Illinois Tollway Base Sheet Revisions			
Section M	Base Sheet Drawings		
	Drawing	Modification Summary	Effective: 03-31-2016
	All	The electronic (pdf) version of the Standard Drawing are now made searchable (text).	
Erosion Sediment Control (ESC)-Series 200			
M-ESC-205	Sediment Basin Dewatering Device		
	Revised Note 7, removed proprietary name from skimmer device.		
Roadway (RDY)-Series 400			
M-RDY-408	Approach Slab, Mainline		
All	Changed Transverse Reinforcement size and spacing in the bottom mat of the bridge approach slab and transition approach shoulder slabs from #6@9" to #8@4" to be in conformance with IDOT ABD Memo 15.8.		
All	Changed Transverse Reinforcement size and spacing in the top mat of the bridge approach slab and transition approach shoulder slabs from #5@12" to #5@6" to be in conformance with IDOT ABD Memo 15.8.		
All	Changed Longitudinal Reinforcement size and spacing in the top mat of the bridge approach slab and transition approach shoulder slabs from #4@15" to #5@6" to be in conformance with IDOT ABD Memo 15.8.

Tollway Base Sheet Revisions		
Section M	Base Sheet Drawings	
	Drawing	Modification Summary Effective: 03-31-2016
	Maintenance of Traffic (MOT)-Ser

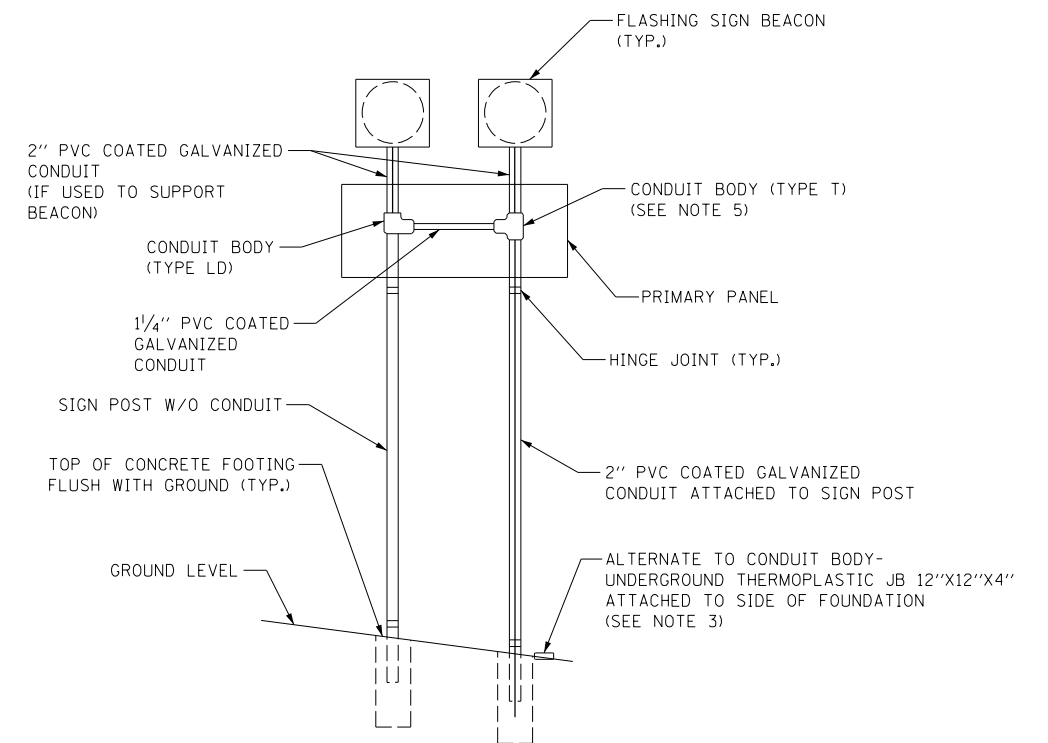
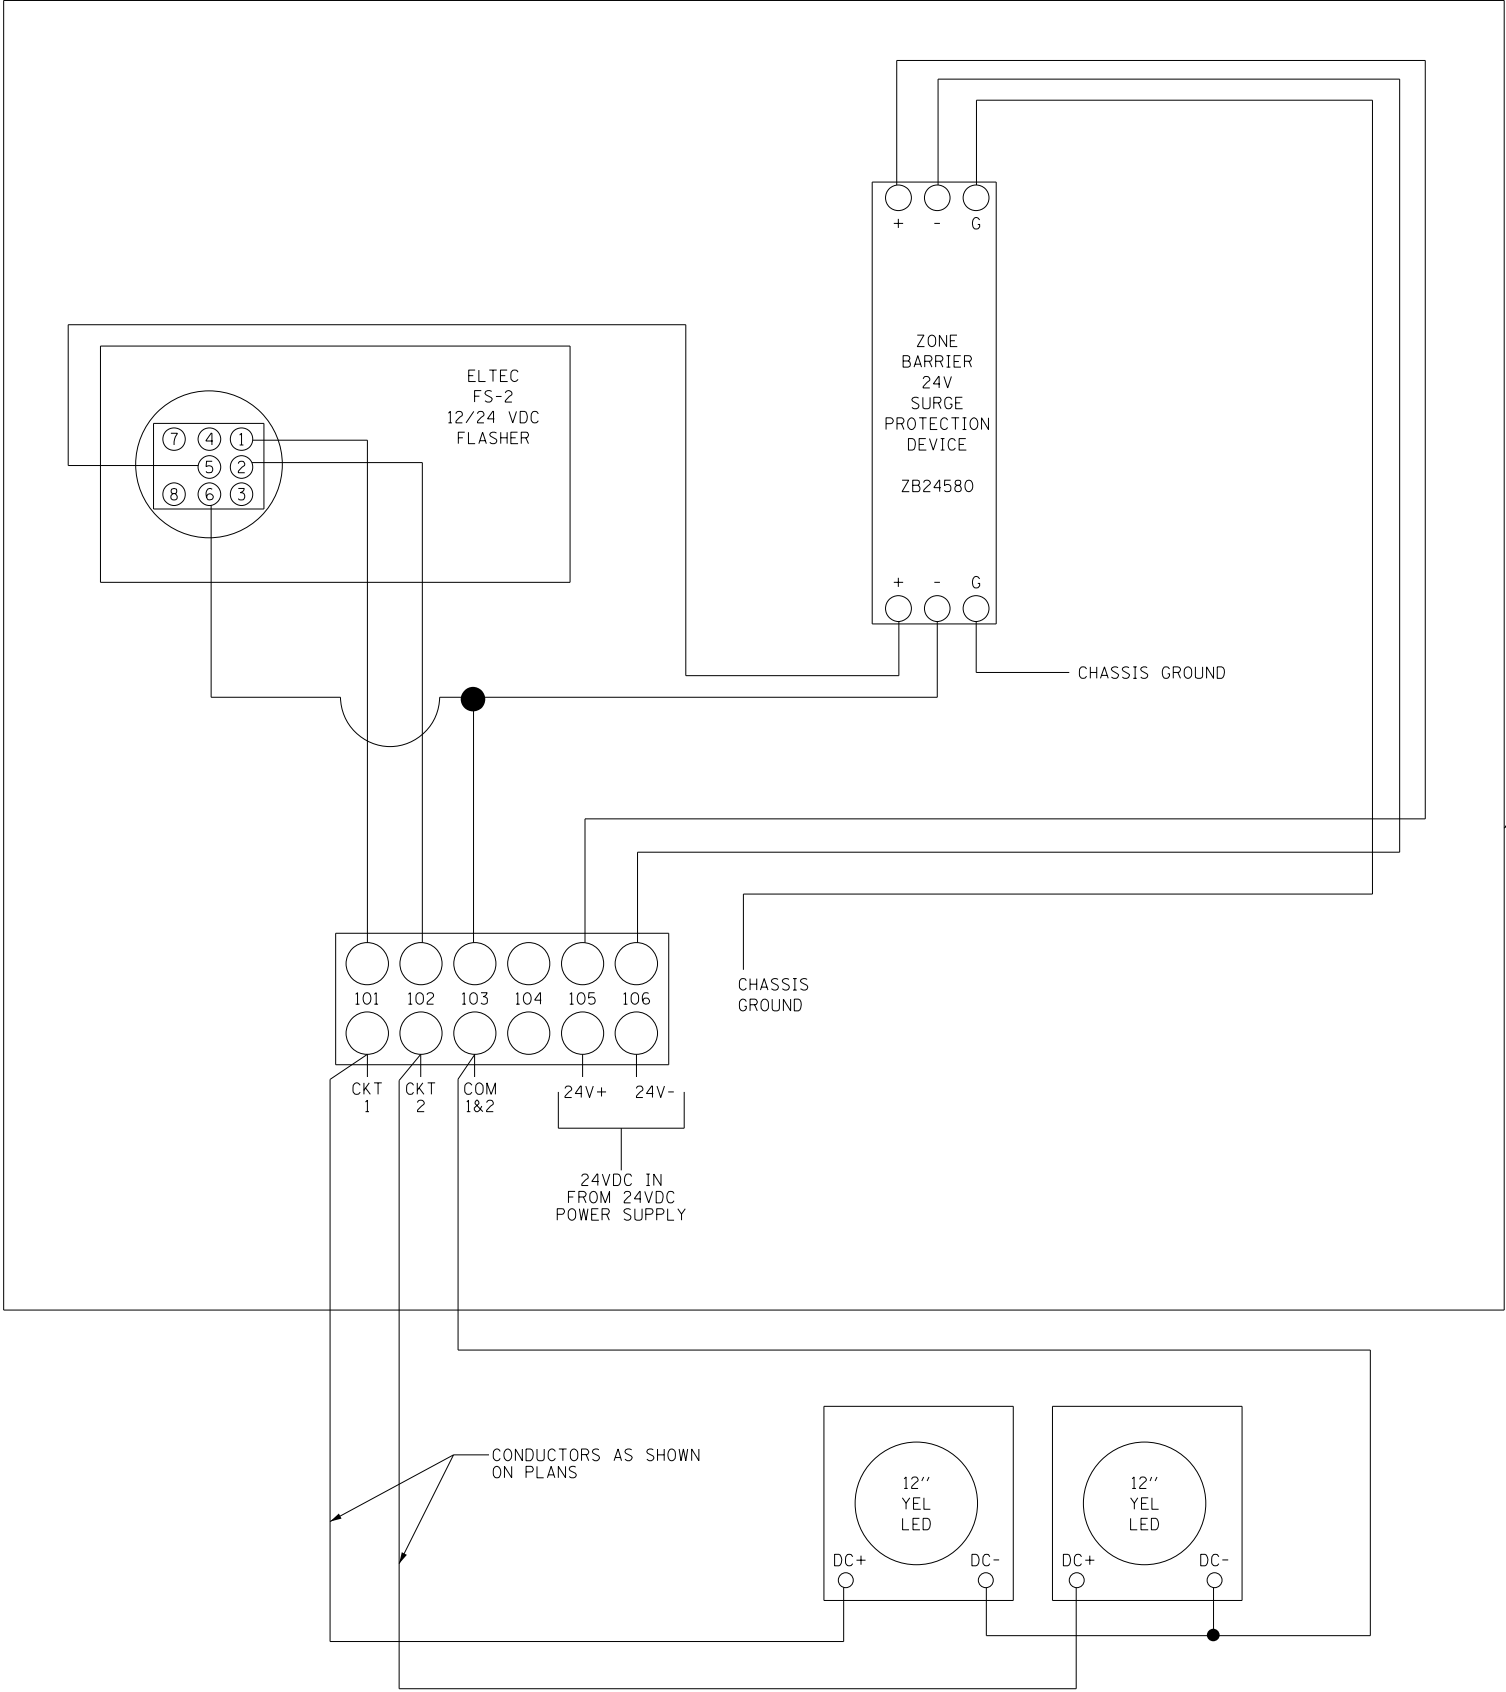
New Sheet
